Contractor:  TIANCHEN CORP. CHINA	Project :	MKP Methanol Project			Owner :  شرکت کیمیای پارس خاورمیانه Middle East Kumiya Pars Co.
	Unit	General Technical	Phase	Detail Engineering	
	Doc. Title :	PACKAGE HAZOP			
Vendor :  新鼎信息技術(上海)有限公司 Advanced Control & Information Technologies Co., Ltd.	Owner No.	MKP-11-DE-9000-SF-RPT-001B			Rev. : 0
	Contr. No.:	MKP-11-DE-9000-SA01-RPT-001B			
	Vendor No.	16E2416A			Page : 1 of 25

PACKAGE HAZOP

Node 7009

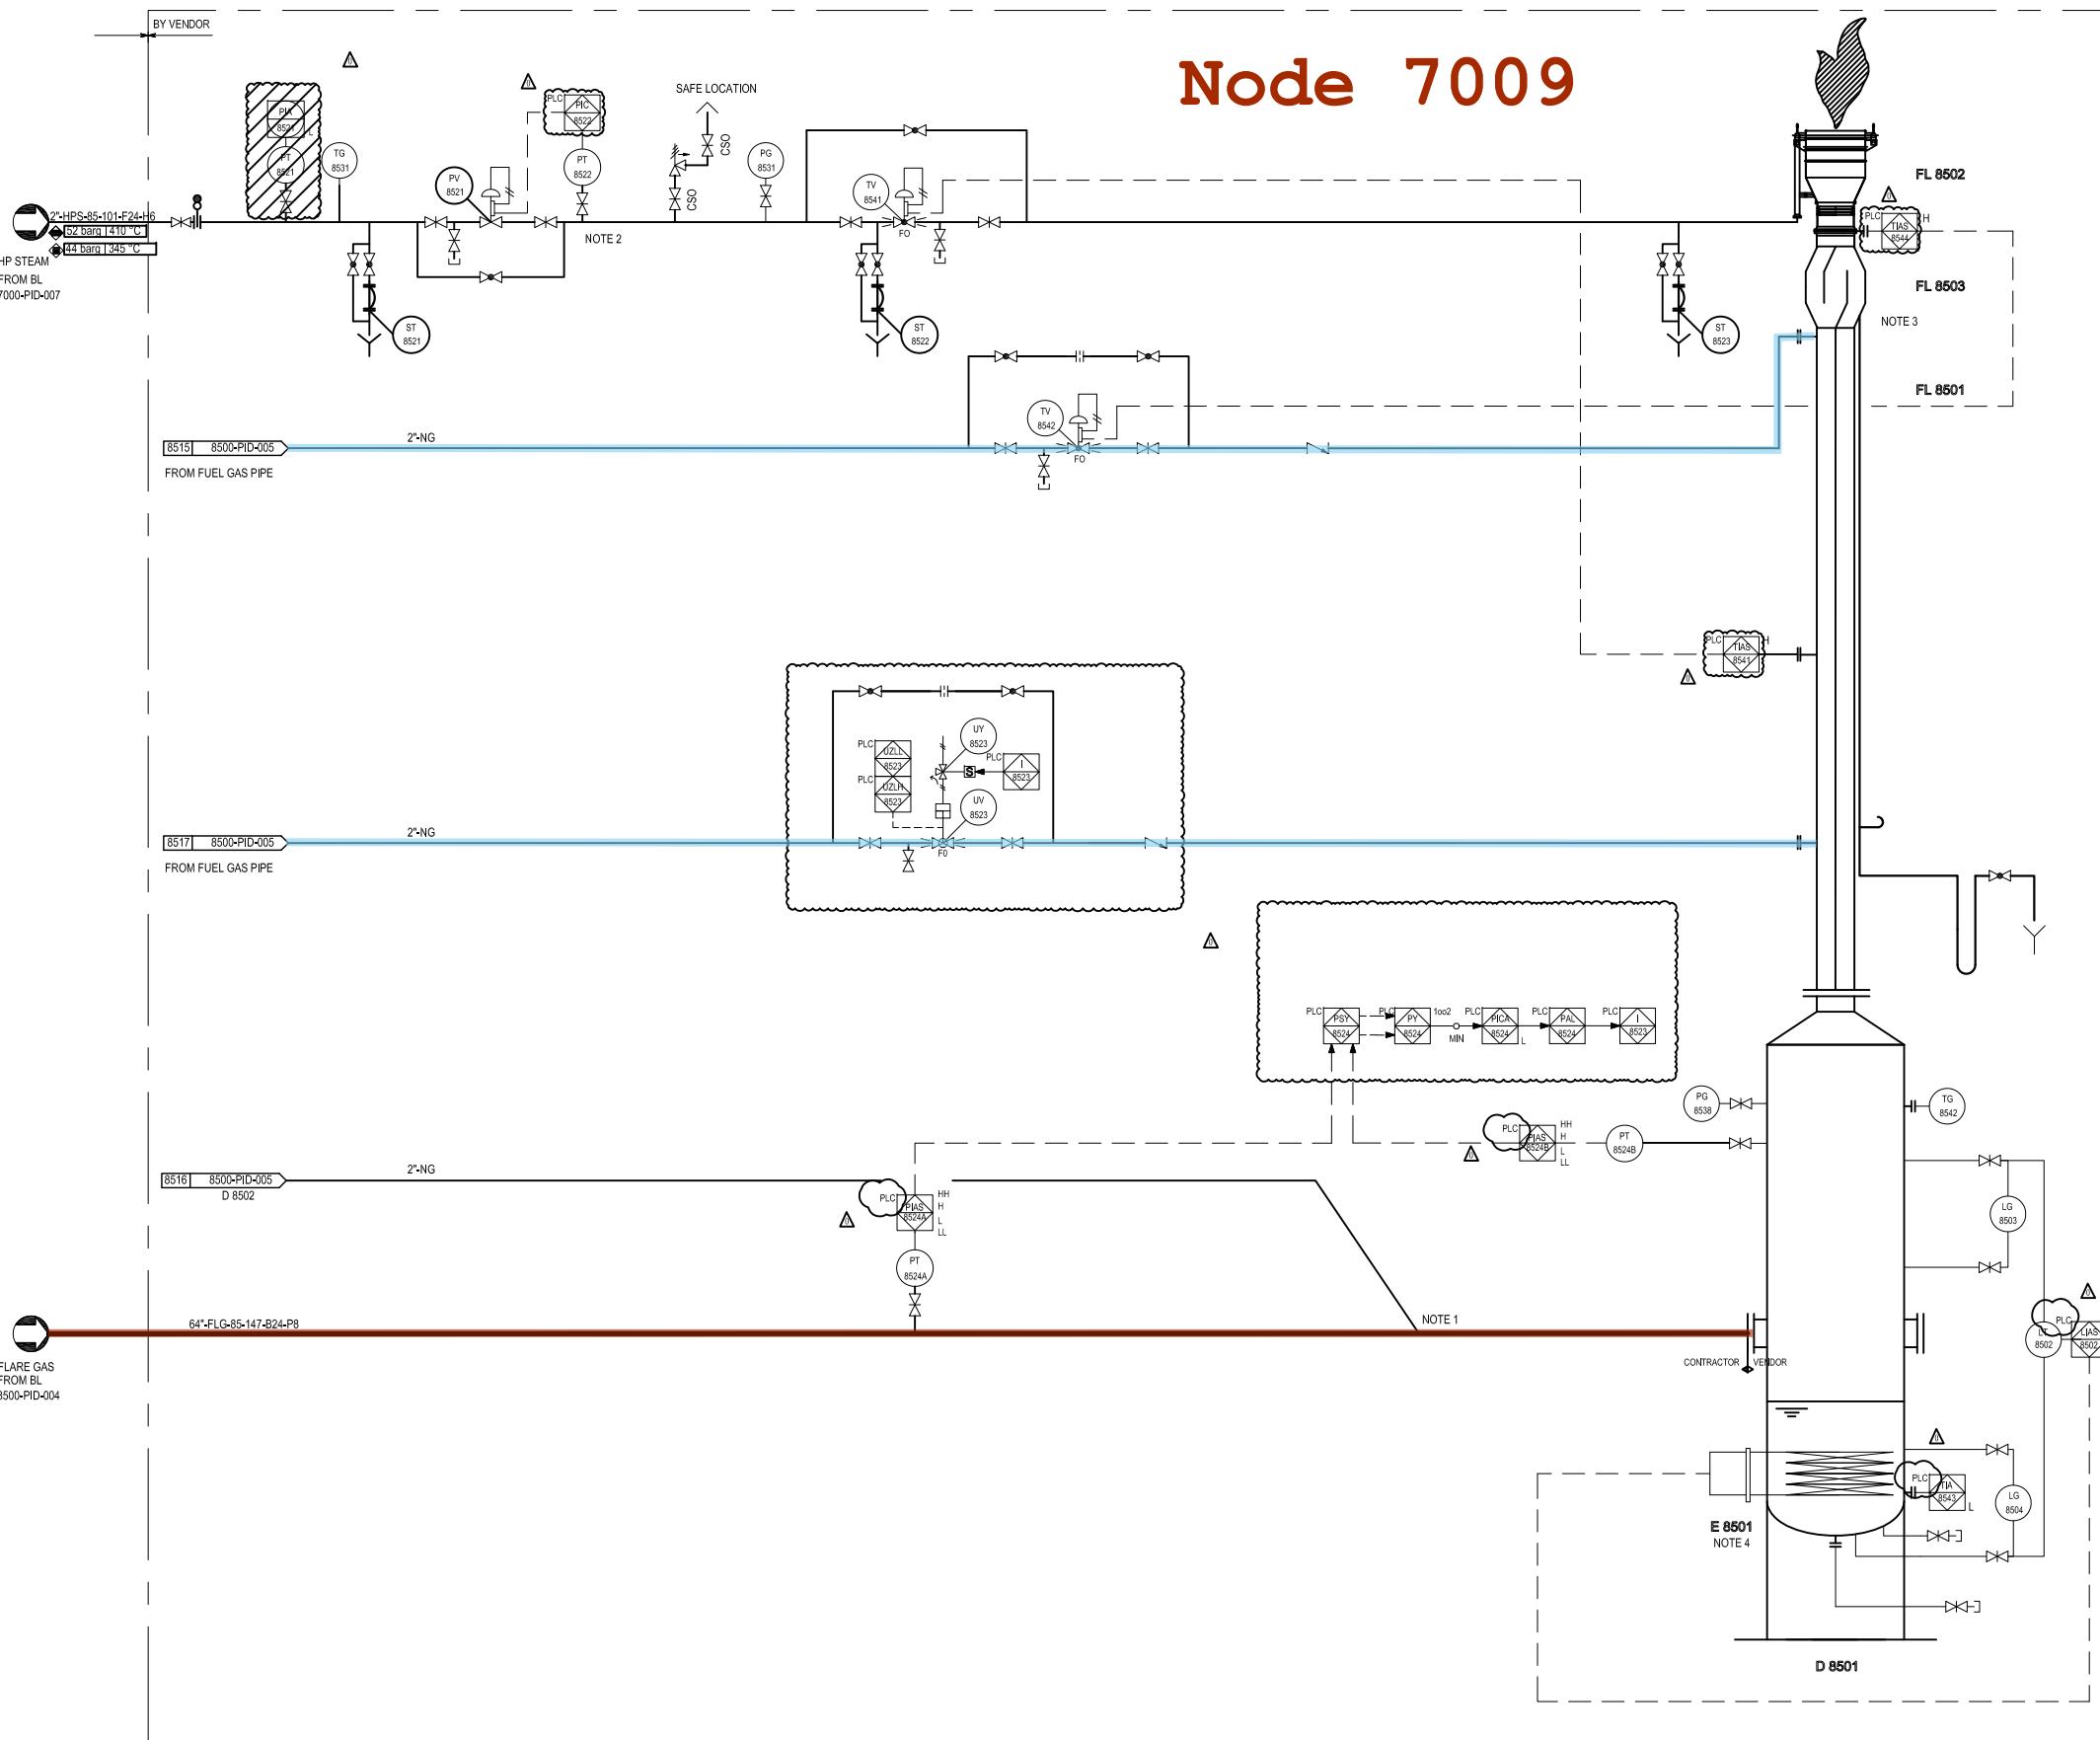
7009.11	3	Vendor to advise: TIAS/TV-8544 as a safeguard.	Y			TCC
7009.13		HAZOP study should be done by vendor for flare gas system package, the owner will check flare package after receiving vendor data.	Y			TCC
7010.9	2	1.Add plant air connection for portable pumps.	Y			TCC
7010.13		1.Consider curb with anti-acid brick for H ₂ SO ₄ solution tank and NaOH solution tank.	Y			TCC
7201.3	2	1.Add a temperature transmitter and send the signal to control room, set high alarm in the 8"-TC-72-201-B50-N inlet line of X-7201A/B and X-7204.	Y			TCC
7201.5	3	1.Change FIQ-7204 to FI-7204.	Y			TCC
7201.6	2	1.Add low alarm for FT-7205.	Y			TCC
7201.7	2	1.Add low alarm for FI-7201. 2. Add FI and low alarm for FI-7204 (DMW from B.L)	Y			TCC
7201.8	2	1.Add low alarm for FT-7203A/B.	Y			TCC

. 7	high pressure(D-8502)	1 PT/PIC/PV-8529 fail open.	D-8502 overpressure.	D-8502 have a PSV.	4	4	4	Y	PG-8541 change to PT-8541 and send a signal to PLC and add high pressure alarm.
. 8	low pressure(D-8502)	1 1.PSV of D-8502 open prematurely or leak. 2.PT/PIC/PV-8529 fail closed.	Pilot gas supply failure.	PIA-8527 low pressure alarm.	3	4	3	N	PG-8541 change to PT-8541 and send a signal to PLC and add low pressure alarm.
. 9	low pressure(flare gas)	1 No significant issue identified.						N
